# **Structural Special Inspections Report**

## **Florence House**

190 Valley Street

Structural Engineer of Record  
Becker Structural Engineers, Inc.

#### Canopy along Line 1 - West:

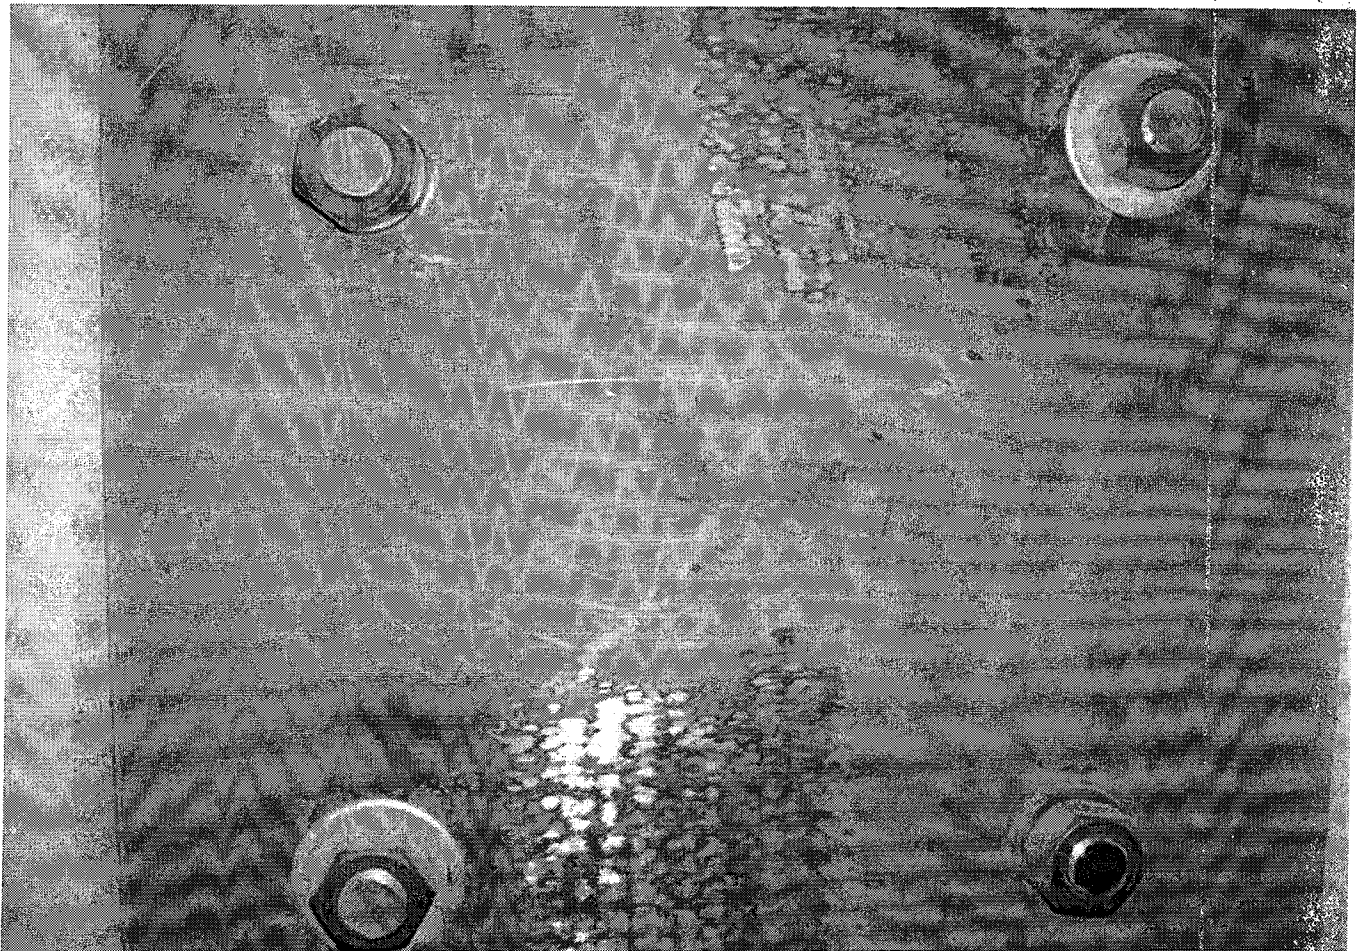
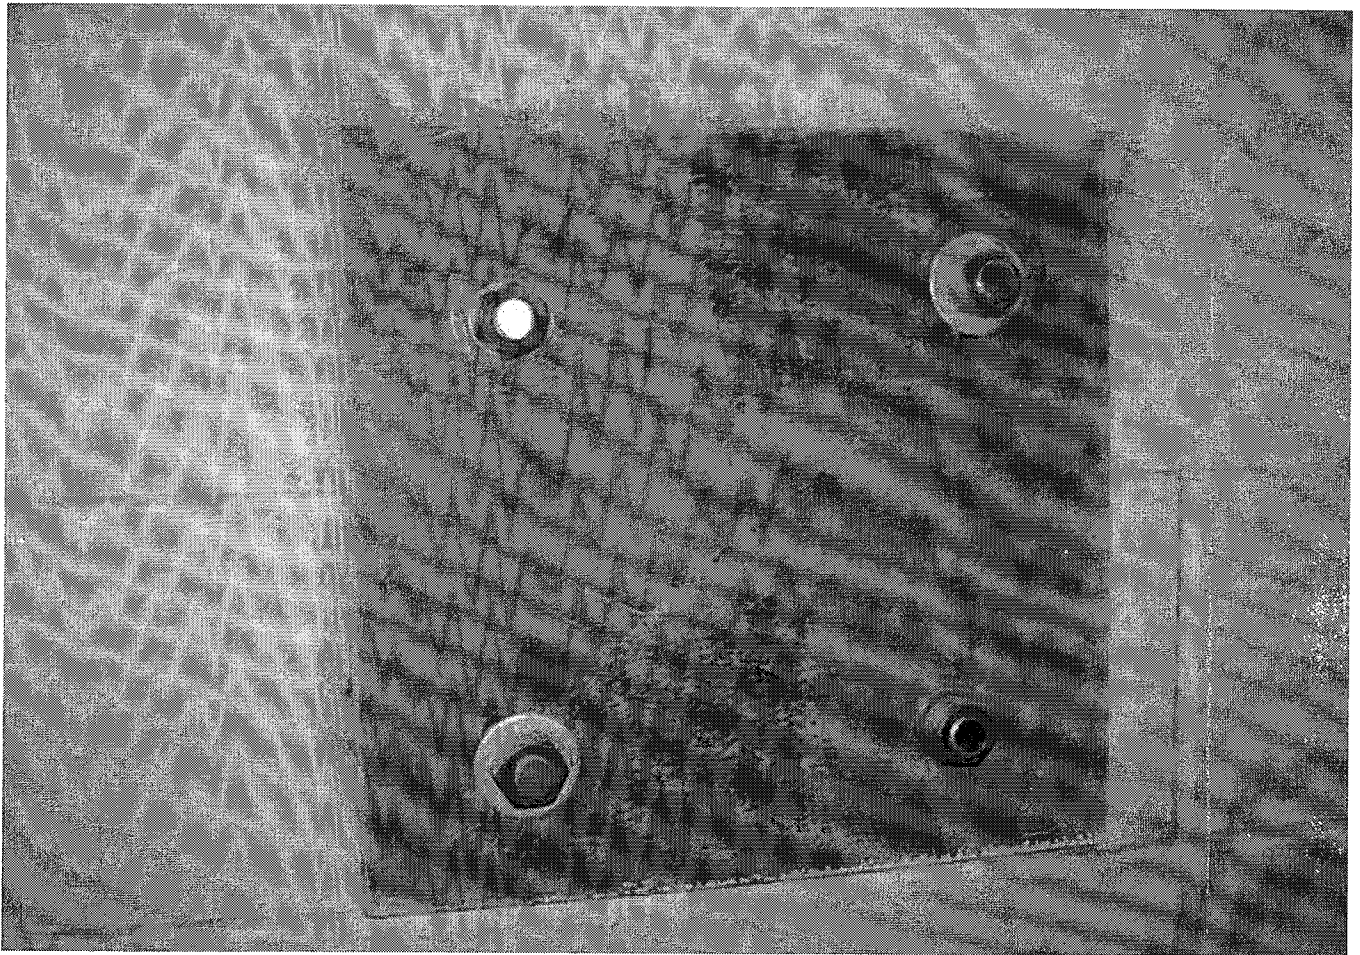
6. The bolts through the CMU wall are not adequately installed for connection of the tension rod to the CMU. Two bolts have missing nuts, and these bolts were spot welded to the steel plate at the inside face of the wall. This was discussed with Everett Stewart of Ganneston Construction, and will be repaired as follows: Shore the canopy, grind out out plug welds, and remove the nuts and plate at the interior side of the CMU wall. Cut away a minimal section of the wall as

necessary to expose the bolts, and install coupler nuts to extend a threaded rod for proper attachment of the plate. Grout around the coupler nuts flush with the inside face of the wall, and replace the plate. 01/13/10: Per subsequent conversation for Everett Stewart, an alternate repair was completed. A written explanation of the repairs completed shall be submitted to BSE for review and record. A follow-up inspection can be conducted following receipt of the repair documentation. 02/04/10: This item has not been reviewed after completion of above instructions. **03/04/10: Documentation provided by General Contractor along with supporting photographs. Item is CLOSED.**
